TO: Mercedes-Benz Dealer Principals, General Managers, Sales Managers, Service Managers, Parts Managers	FROM: Gregory Gunther, Department Manager, Vehicle Compliance and Analysis, Engineering Services
RE: Emission Modification Notification – [[2020050023]] MY 09 R320 BlueTec 4MATIC Update – Emission Modification Category (EMC) #5	DATE: May 27, 2022

Campaign No. 2020050023, January 2022

SUBJECT: **Model R-Class diesel vehicles (V251 platform)**
Model Year 2009
Modification to the emission control system

Figure 4

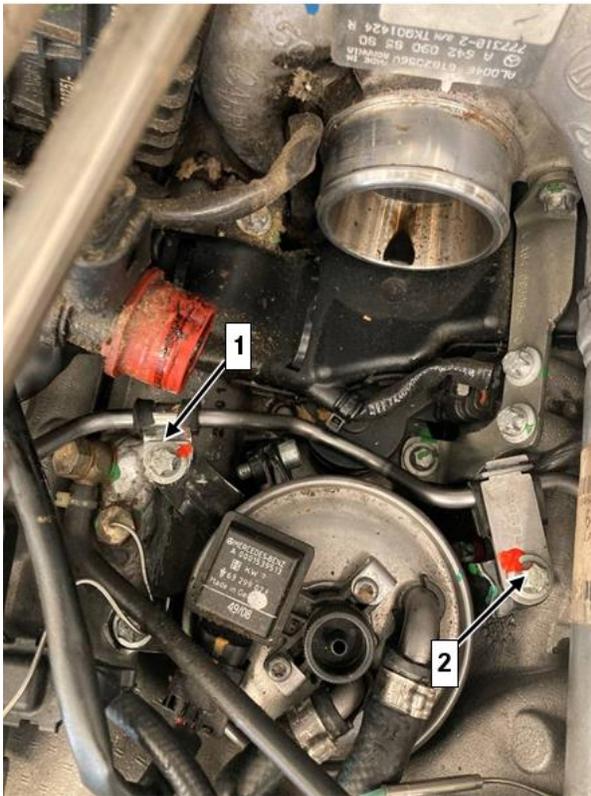
- i** The line from the left fuel distributor to the right fuel distributor is replaced by a new version (A 642 070 09 00) (**Figure 4**). A new clamp (1, **Figure 4**, (N 000000 006288)) with new bolt (2, **Figure 4**, (N 000000 001116 M6x19mm)). The old bracket on position (2, **Figure 4**) is reused and with a new bolt (N 000000 001114 M6x15mm) fastened. The old bracket must be reinstalled as shown. Chafe-free routing must be ensured.

Figure 6

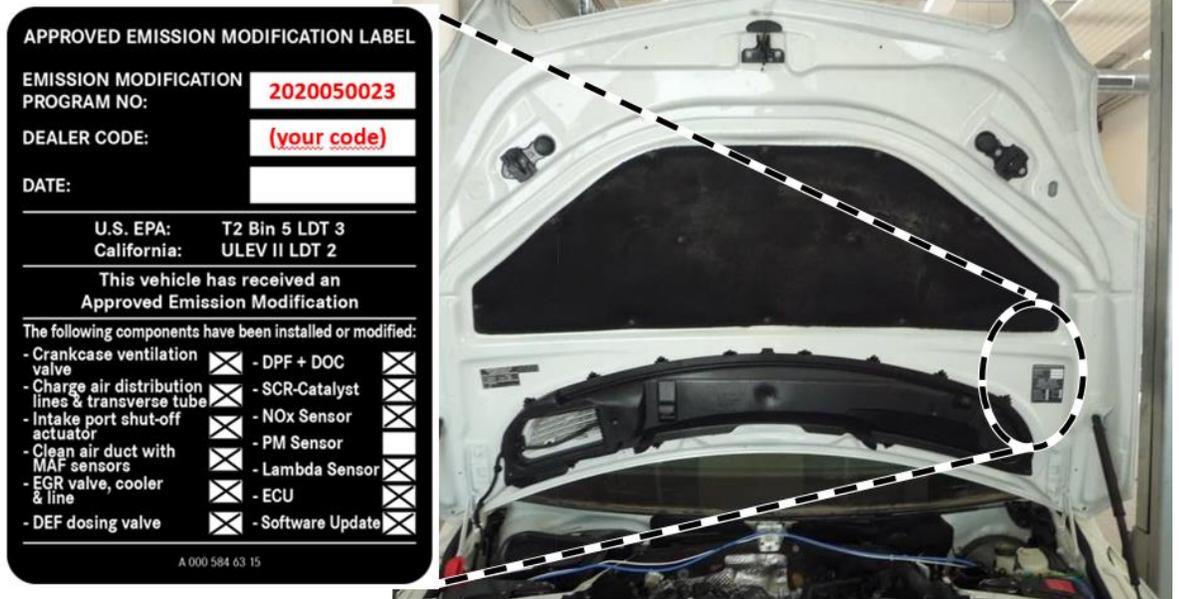
13. Clean the bonding surface of the hood and attach the adhesive label (A 000 584 63 15) (**Figure 6**).

i The fields on the adhesive label must be filled out correctly. Please use black permanent marker. Refer to (**Figure 6**) within the XENTRY procedure.
